SLIGO APARTMENTS

PRELIMINARY PLAN

RE: Preliminary Plan No. 12022011A
Sligo Apartments
Preliminary Plan Letter

R.HOLT EASLEY'S LOTS 51,12, & PT. OF LOT 10
SLIGO APARTMENTS
FIRE ACCESS PLAN AMENDMENT

PP2.01

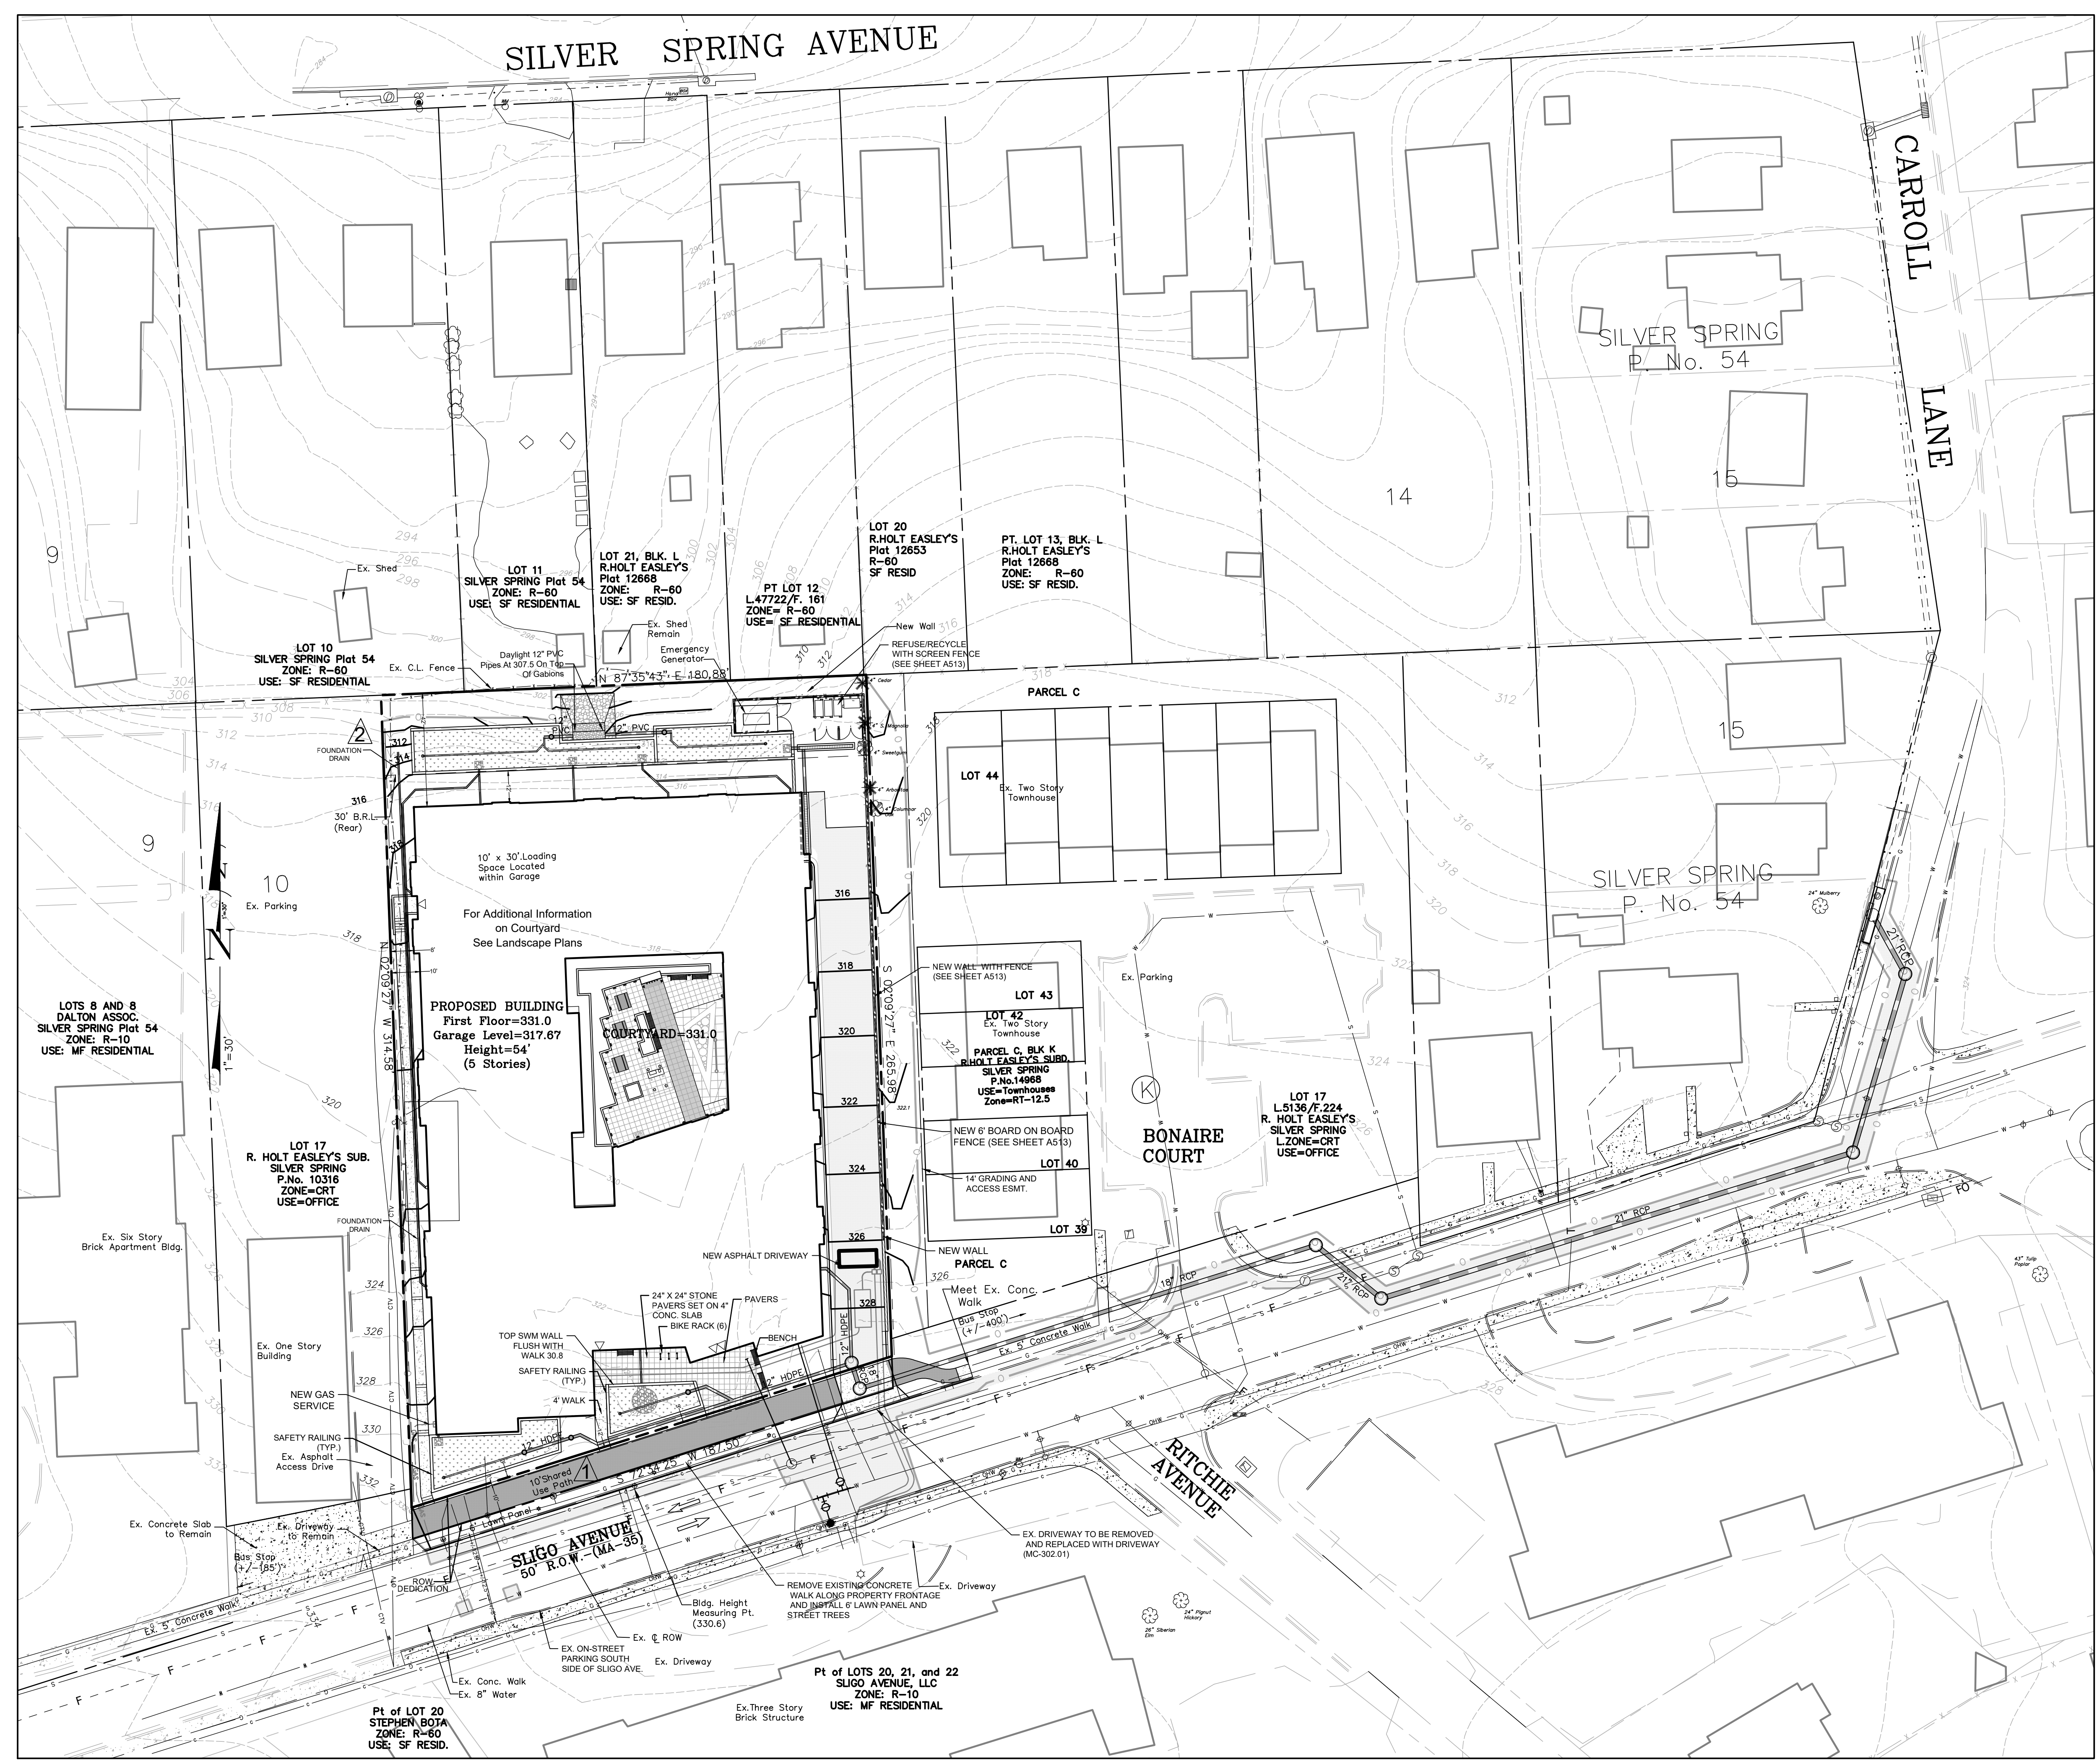
- SUMMARY OF PLAN CHANGES:**
- REVISE ROADWAY SECTION TO REDUCE SHARED USE PATH FROM 10' TO 8' AND EXPAND LAWN PANEL FROM 6' TO 8'.
 - REVISE CONFIGURATION OF THE STORMWATER MANAGEMENT FACILITY AT THE REAR OF THE PROPERTY TO REDUCE THE LIMITS OF DISTURBANCE.

OVERALL SITE PLAN

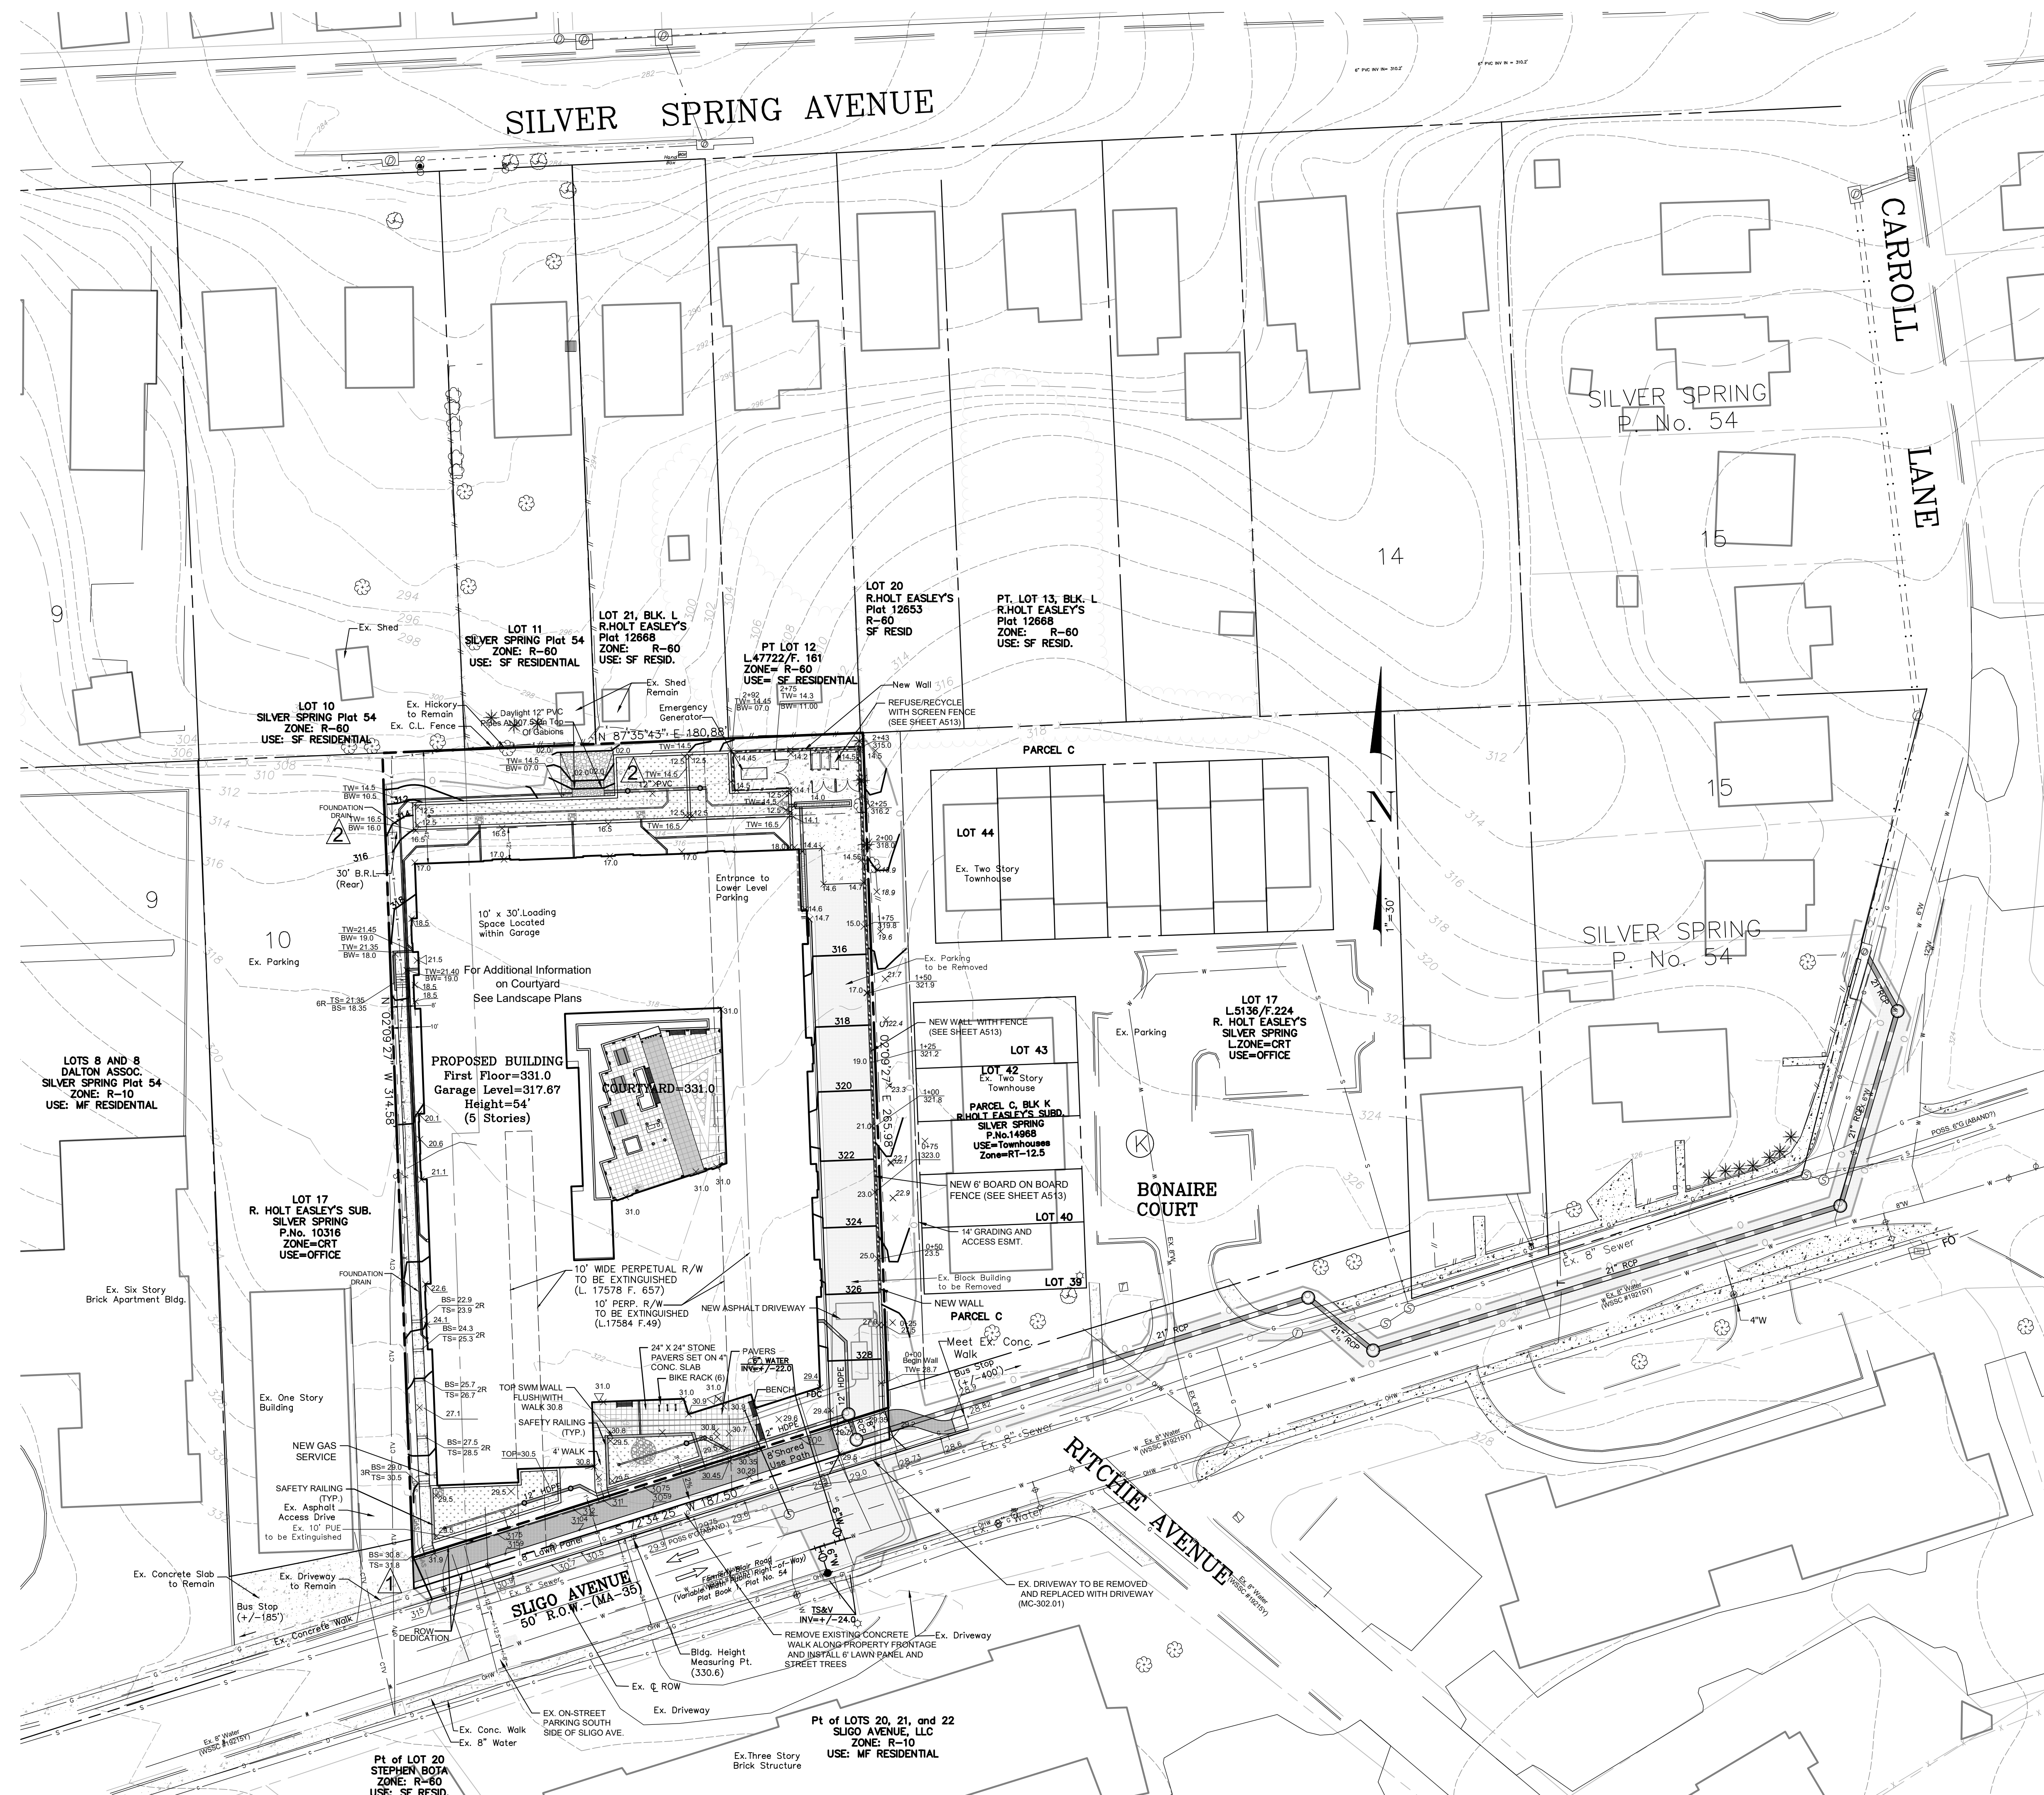
SUMMARY OF PLAN CHANGES:

- REVISE ROADWAY SECTION TO REDUCE SHARED USE PATH FROM 10' TO 8' AND EXPAND LAWN PANEL FROM 6' TO 8'.
- REVISE CONFIGURATION OF THE STORMWATER MANAGEMENT FACILITY AT THE REAR OF THE PROPERTY TO REDUCE THE LIMITS OF DISTURBANCE.

FIRE APPARATUS ACCESS PLAN

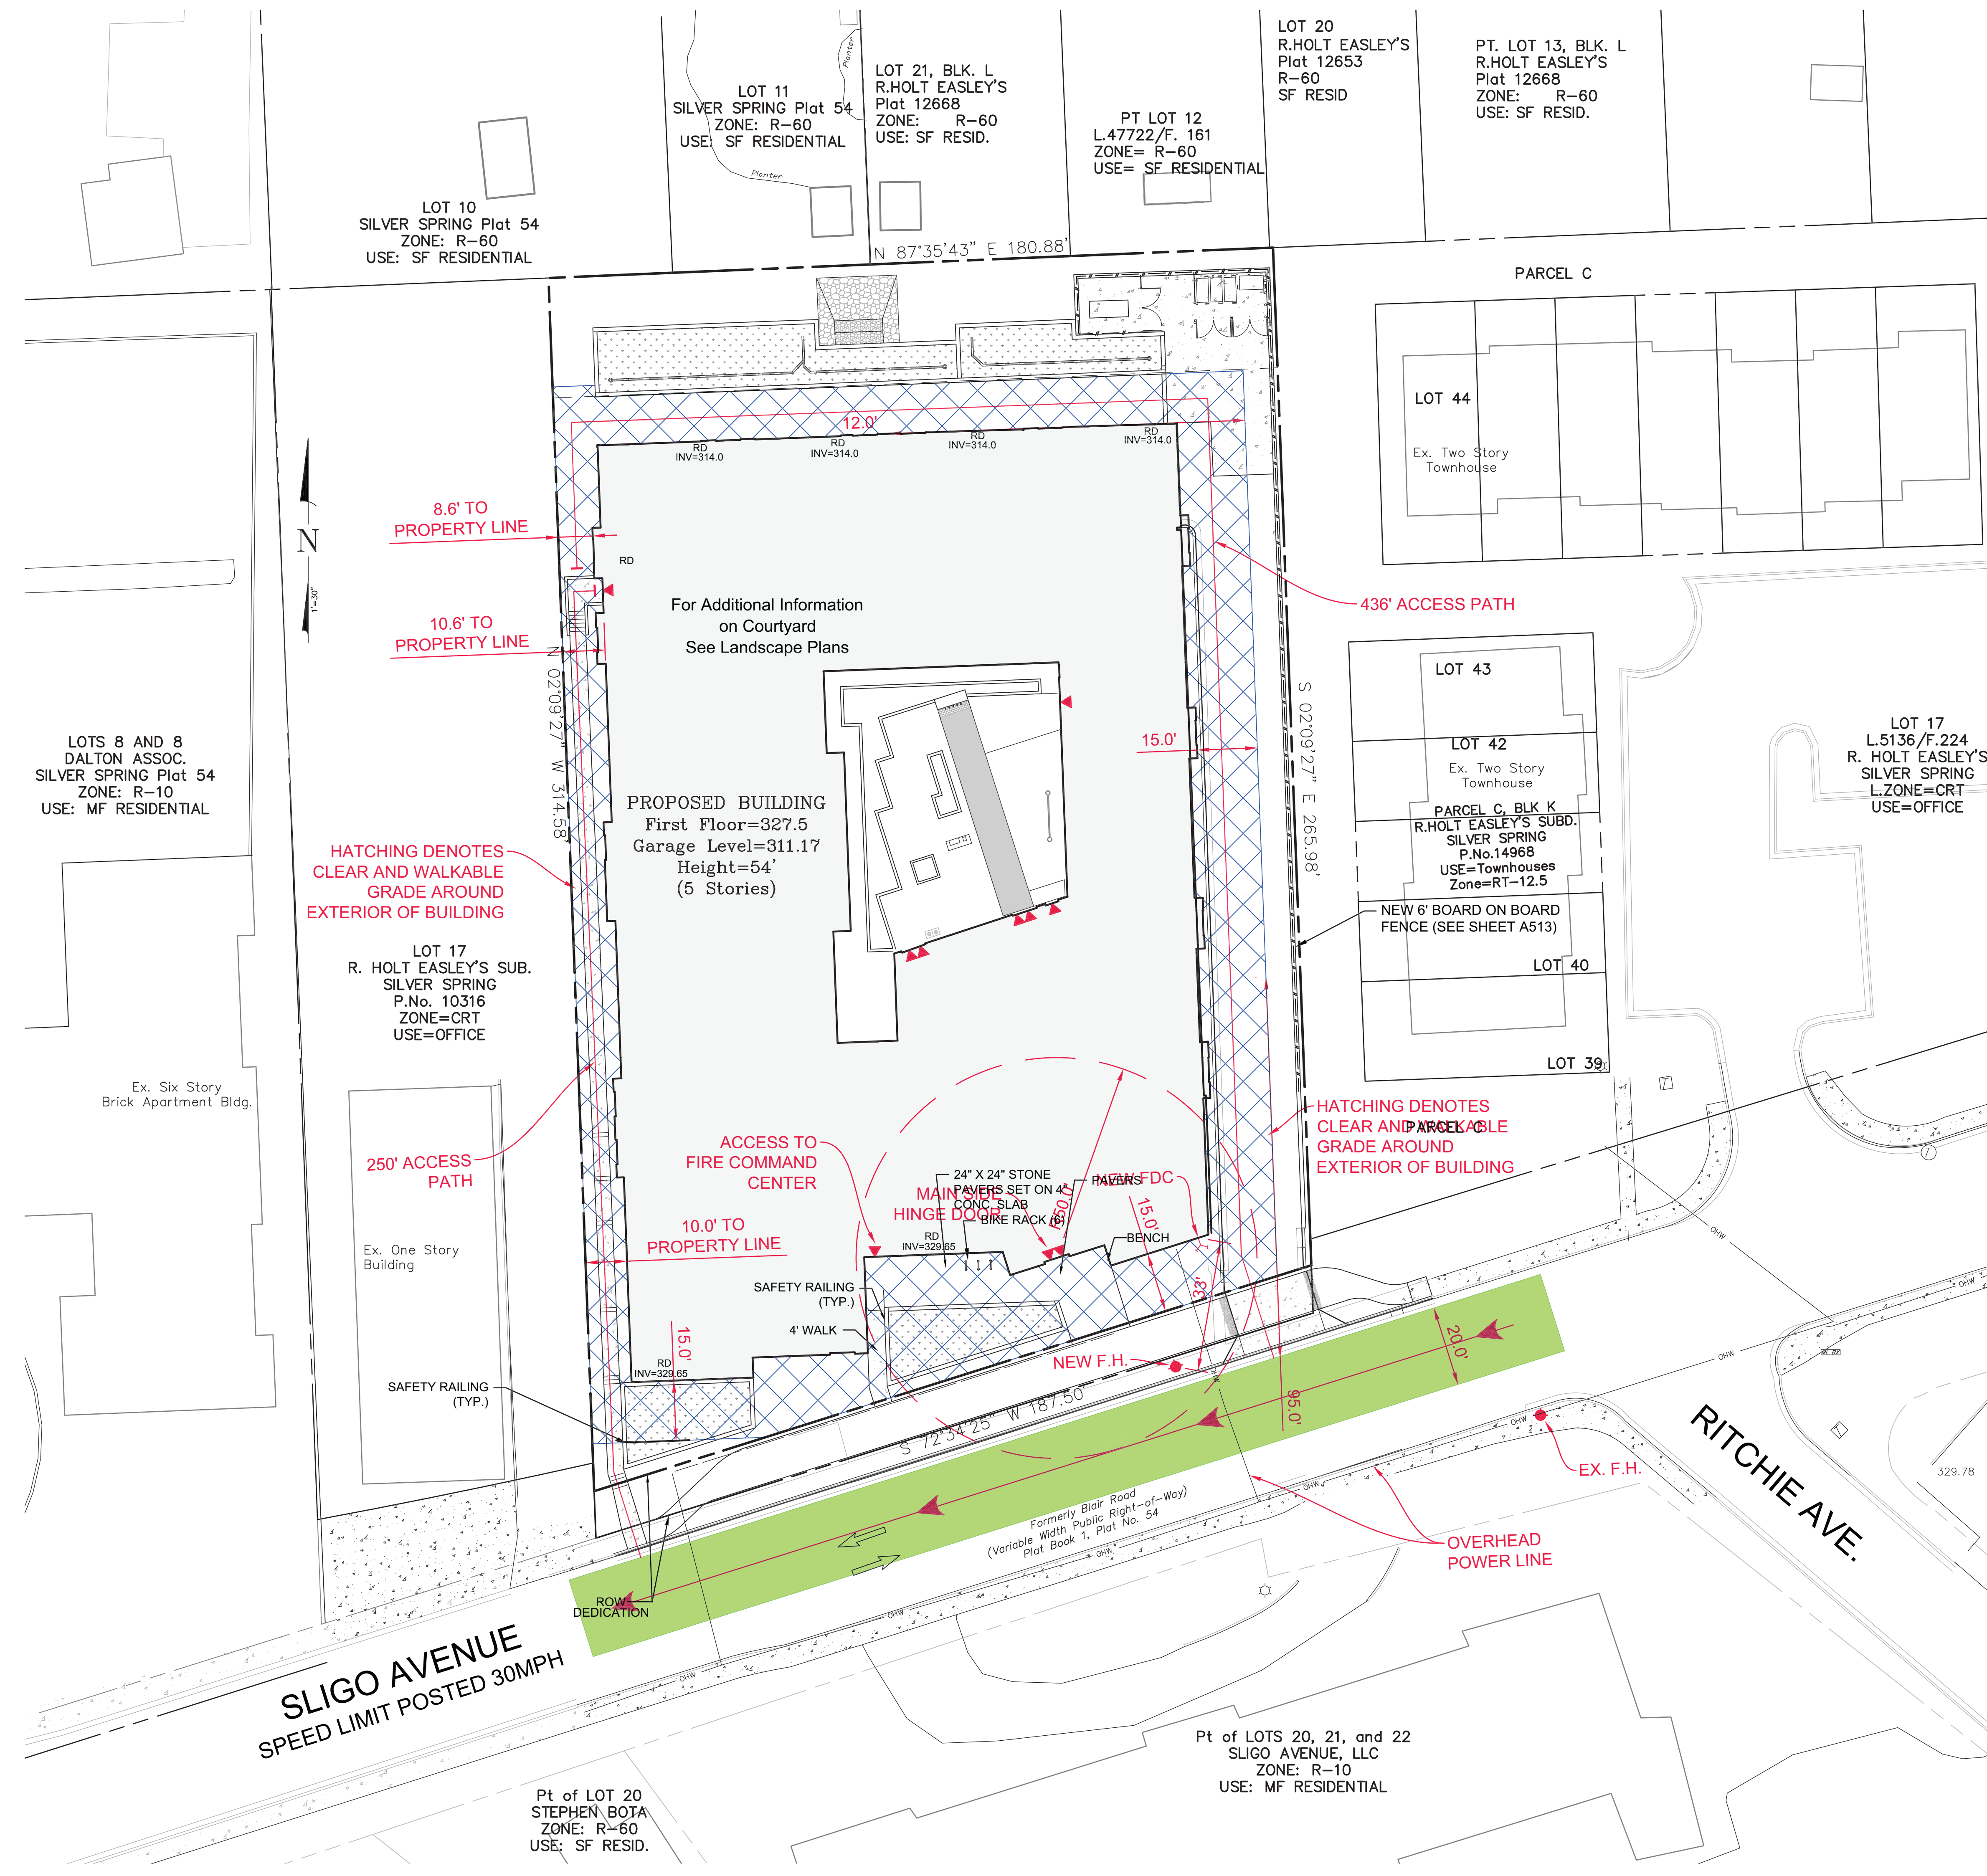
***** 5/12/2023 Revised hydrant location *****

On behalf of our Client, Sligo Apartments L.L.C., we hereby propose a revision to the approved Fire Department Apparatus Access plan as part of the Site Plan and Preliminary Subdivision Plan and amendments. The Fire Department Apparatus Access Plan revisions include: a reduction of the width of the shared use path from 10 feet to 8 feet, reconfiguration of the stormwater management facility, and relocation of the proposed fire hydrant.

The 15'-0" Min. distance between the west property and the building has been reduced to 8' min. The interior building walls will be upgraded to the 2 hours fire rating corridor and units demising walls (compartmentalized to 2 hours fire rated walls). A request will be submitted under a performance based design.
